### Specification Change Notice for Hopper

■Product model: Hopper NJ-80, NJ-80F, SR-80 series

1. Change in the shape of the screw storage cover and associated external dimensions (height)

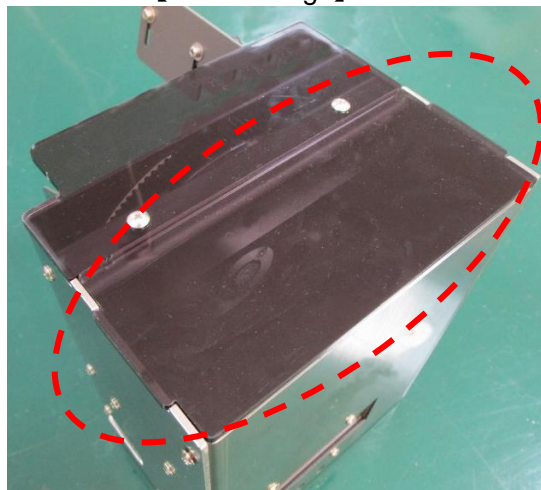
The shape of the screw storage cover will be changed and the height will be increased by 2mm accordingly.

2. Elimination of screw gate adjusting plate

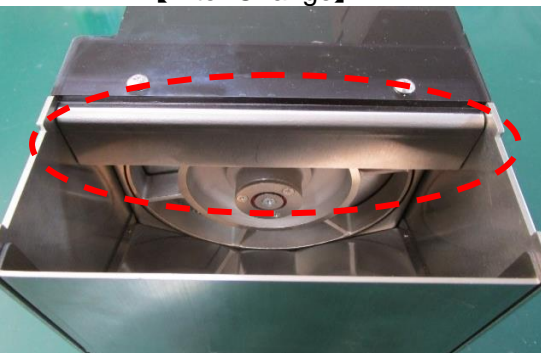
The screw gate adjusting plate is eliminated by integrating it with the main unit.
